Endpoint Solutions

Subject: Work Plan for Additional Investigative Services
Klinke Cleaners Fox Run at 2346 W St. Paul Avenue, Waukesha
DNR BRRTS Activity #: 02-68-535535; FID #: 268188910

WDNR RESPONSE

PROPOSED SCOPE OF WORK

RESIDUAL SOIL CONTAMINATION

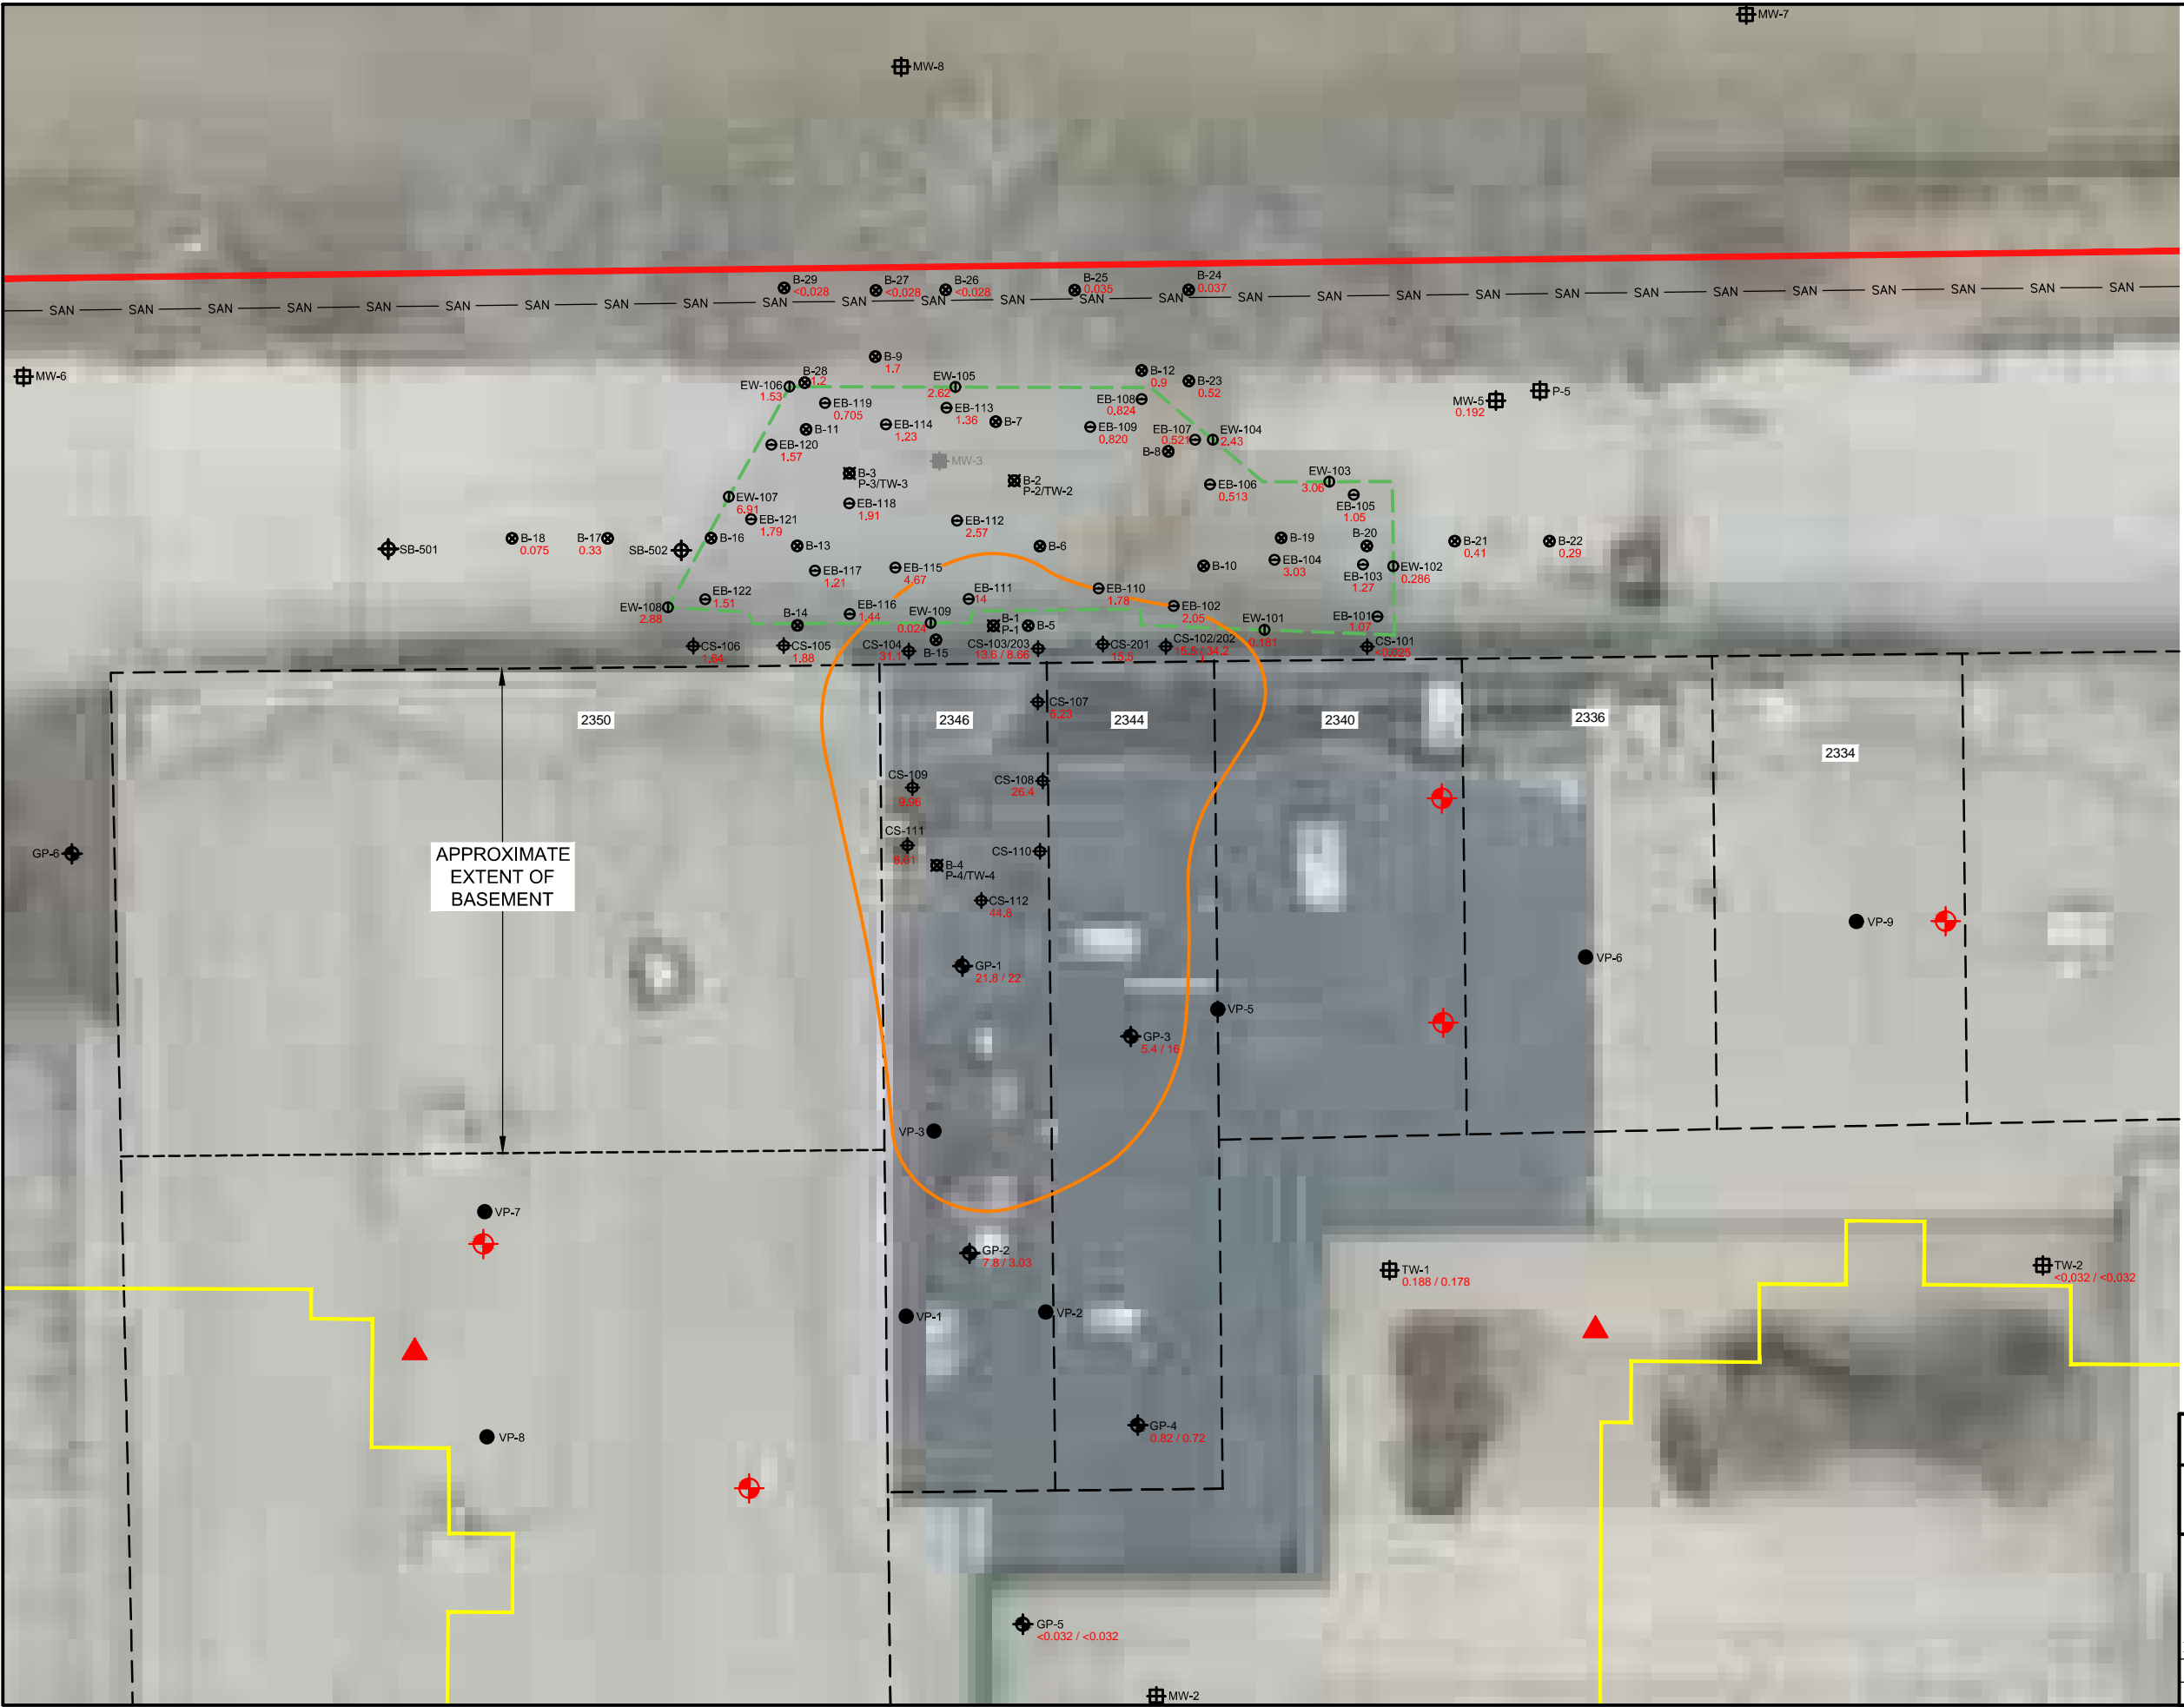
Additional soil samples are needed to define the extent of residual soil contamination, to ensure that material excavated during construction is properly managed, to determine where a soil cover needs to be maintained, and to identify areas at risk from vapor intrusion. Soil samples should be collected in the following areas to assess the extent of contamination:

- The area east of CS-110 to define the extent of tetrachloroethene (PCE) contamination that exceeds direct contact residual contaminant levels (RCLs).
- Areas north, west and southwest of the former Klinke tenant space to define the extent of PCE that exceeds the protection of groundwater RCL. This includes assessing the areas north of B-28 and the area within the sewer trench backfill along the property boundary to determine the northern extent of contamination.

An error was discovered on **Figure B.2.a** and **Figure B.2.b** associated with the locations of soil sample locations B-28 and B-29. As shown on Figure 3 from the Saga November 14, 2011 Status Report, soil sample B-29 is actually located to the north of soil sample B-28; therefore, the extent of contamination to the north of the B-28 location has been delineated. A copy of the original Figure 3 from the Saga November 14, 2011 Status Report is attached in **Appendix A** and these two (2) sample locations have been corrected on **Figure B.2.b**, attached. Based on this information, it is our opinion that no further investigation is required to the north of the B-28 location.

We propose to advance three (3) soil borings to the east of the CS-110 sample location; two (2) along the eastern edge of the former 2340 tenant space and one (1) along the east edge of the former 2334 tenant space. The proposed locations of these soil borings are depicted on **Figure B.2.b**. Based on the depth of groundwater encountered in soil borings GP-1 through GP-4 advanced within the 2344 and 2346 tenant spaces, these soil borings will be advanced to a maximum depth of ten (10) feet below the ground surface (ft bgs). Two (2) unsaturated soil samples from each soil boring location will be submitted for volatile organic compound (VOC) analysis. One (1) sample will be submitted from the zero (0) to four (4) ft bgs interval and the second sample will be submitted from below four (4) ft bgs but above the apparent water table.

The alignment of the gravity sanitary sewer located along the north property line onto **Figure B.2.b**. Soil samples B-24, B-25, B-26, B-27 and B-29 appear to have been advanced within the sanitary sewer trench backfill. In this location, the top of the six-inch (6") diameter sanitary sewer is approximately 14 ft bgs. Data could not be obtained regarding the depth of the samples collected; however, all of the results were below or slightly above the method detection limit (MDL) of 0.028 micrograms per liter ($\mu\text{g/L}$) PCE. Based on these results, it is our opinion further assessment of the sanitary sewer backfill is not necessary.

advance two (2) soil borings in the northeast corner of the slab-on-grade in the 2350 tenant space. The proposed locations of these borings are depicted on **Figure B.2.b**. These soil borings will be advanced to a maximum depth of ten (10) feet below the ground surface (ft bgs). Two (2) unsaturated soil samples from each soil boring location will be submitted for VOC analysis. One (1) sample will be submitted from the zero (0) to four (4) ft bgs interval and the second sample will be submitted from below four (4) ft bgs but above the apparent water table.

In order to further evaluate the potential for vapor intrusion in the two (2) proposed residential buildings closest to the known area of contamination, we propose to install two (2) soil gas sample probes: one (1) adjacent to the northeast corner of the proposed western residential building; and, one (1) adjacent to the proposed northwest corner of the east residential building. The proposed locations of the soil gas sample probes are depicted on **Figure B.2.b**.

GROUNDWATER RESULTS

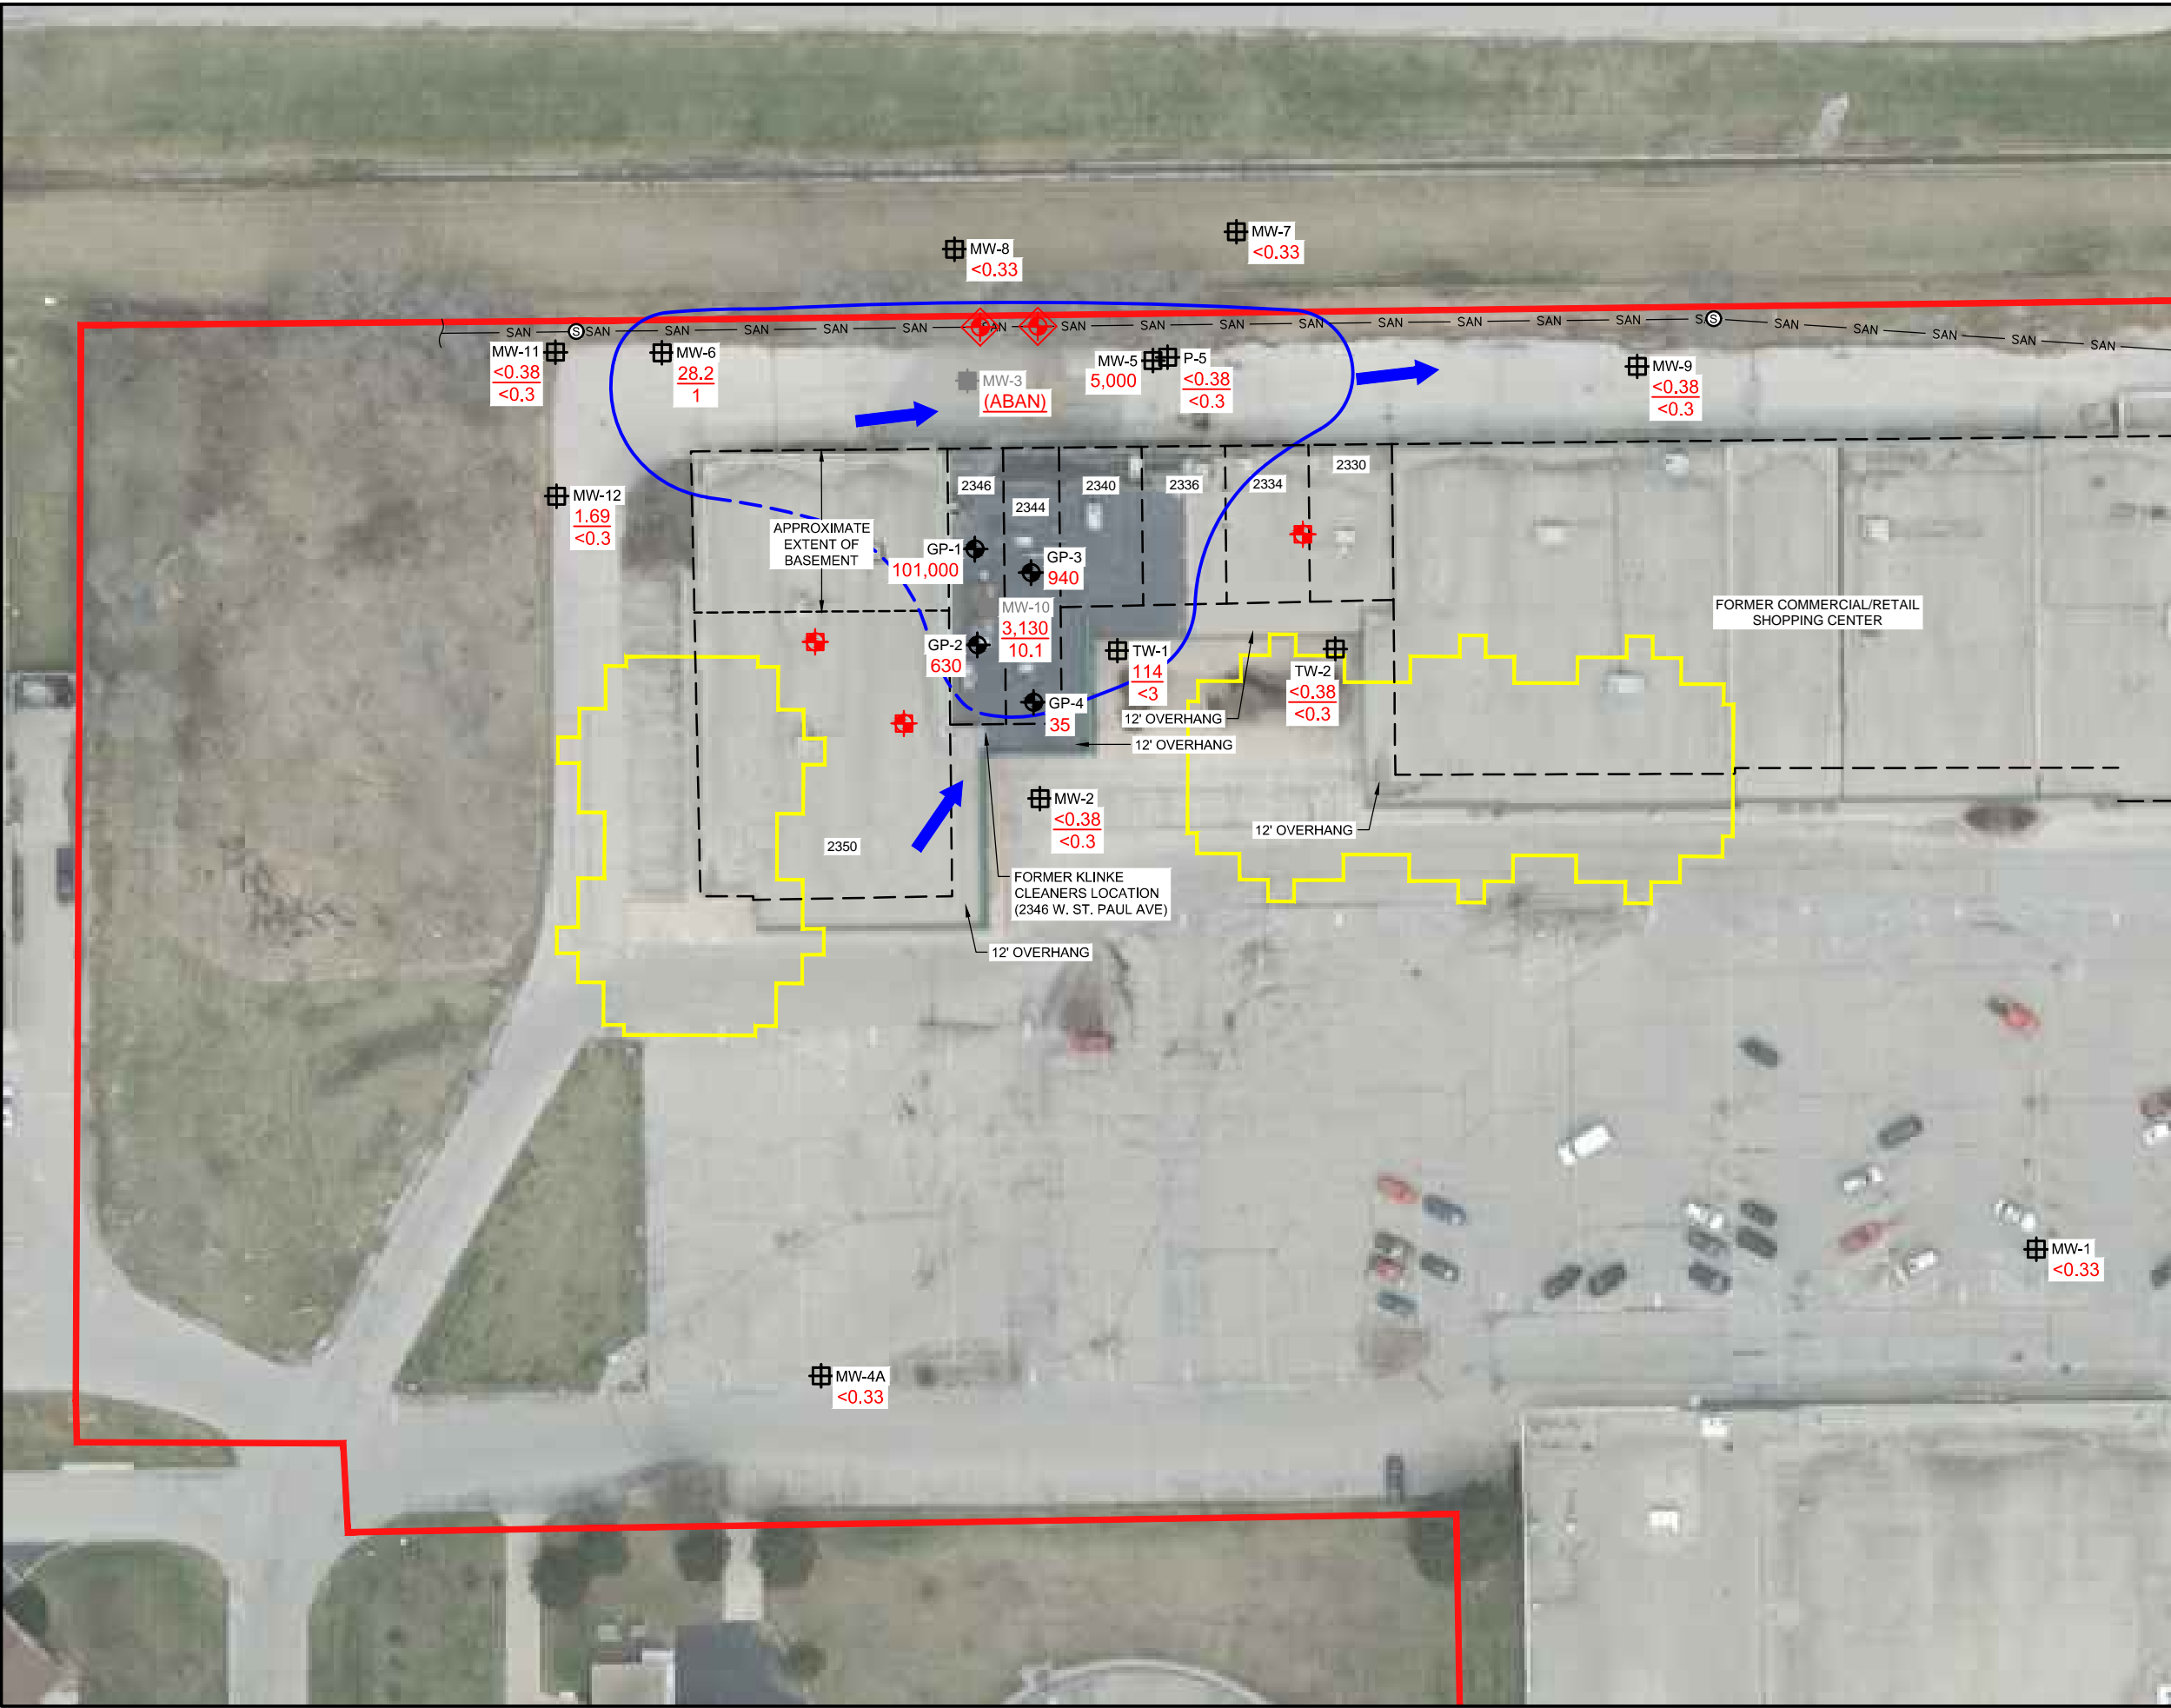
Shallow groundwater samples are needed in the following area to define the extent of the groundwater plume:

- The area southwest of the former Klinke tenant space between GP-1 and GP-2. Collecting sample(s) in this location should confirm whether contaminated groundwater will be in contact with the nearby proposed building foundation which is necessary for assessing the vapor intrusion risk and for planning potential vapor mitigation methods.

- The area between TW-2 and MW-9 to better define the eastern extent of the groundwater plume and to assess a potential easterly groundwater flow direction.
- Near, or within, if possible, the backfill of the sewer along the property line that is planned to be abandoned, to determine if it is acting as a migration pathway for groundwater contamination and if further assessment may be needed.
- New sampling points must be surveyed relative to existing wells so groundwater elevation data can be obtained.

We propose to convert the aforementioned two (2) soil borings proposed in the northeast corner of the slab-on-grade portion of the 2350 tenant space to §NR 141 Wis. Admin. Code compliant monitoring wells. The locations of the proposed monitoring wells are depicted on **Figure B.3.b**. We propose a ten-foot (10') section of factory cut No. 010 screen be installed between approximately five (5) and 15 ft bgs. The wells will be completed with stick-up protector pipes. If necessary, the wells can be converted to flush-mount installations during site grading activities. The top of casing and ground surface will be surveyed using the North American Vertical Datum of 1988 (NAVD88). The wells will be properly developed and samples will be collected for VOC analysis. Depth to groundwater measurements and samples will also be collected from the following existing monitoring wells: MW-2, MW-5, MW-6, MW-7, MW-8, MW-9, MW-11 and MW-12 and piezometer P-5 for VOC analysis.

We propose to convert the aforementioned soil boring proposed to the east of the Klinke Cleaners location along the eastern edge of the 2334 tenant space to a §NR 141 Wis. Admin. Code compliant monitoring wells. The locations of the proposed monitoring wells are depicted on **Figure B.3.b**. We propose a ten-foot (10') section of factory cut No. 010 screen be installed between approximately five (5) and 15 ft bgs. The wells will be completed with stick-up protector pipes. If necessary, the wells can be converted to flush-mount installations during site grading activities. The top of casing and ground surface will be surveyed using the NAVD88. The wells will be properly developed and samples will be collected for VOC analysis. Depth to groundwater measurements and samples will also be collected from the following existing monitoring wells: MW-2, MW-5, MW-6, MW-7, MW-8, MW-9, MW-11 and MW-12 and piezometer P-5 for VOC analysis.

While soil samples were previously collected from the sanitary sewer trench backfill, groundwater samples do not appear to have been collected. We propose to advance two (2) soil borings within the sanitary sewer trench backfill to the north of the 2344 and 2346 tenant spaces to allow for the collection of grab groundwater samples. The locations of the proposed grab groundwater samples are depicted on **Figure B.3.b**.
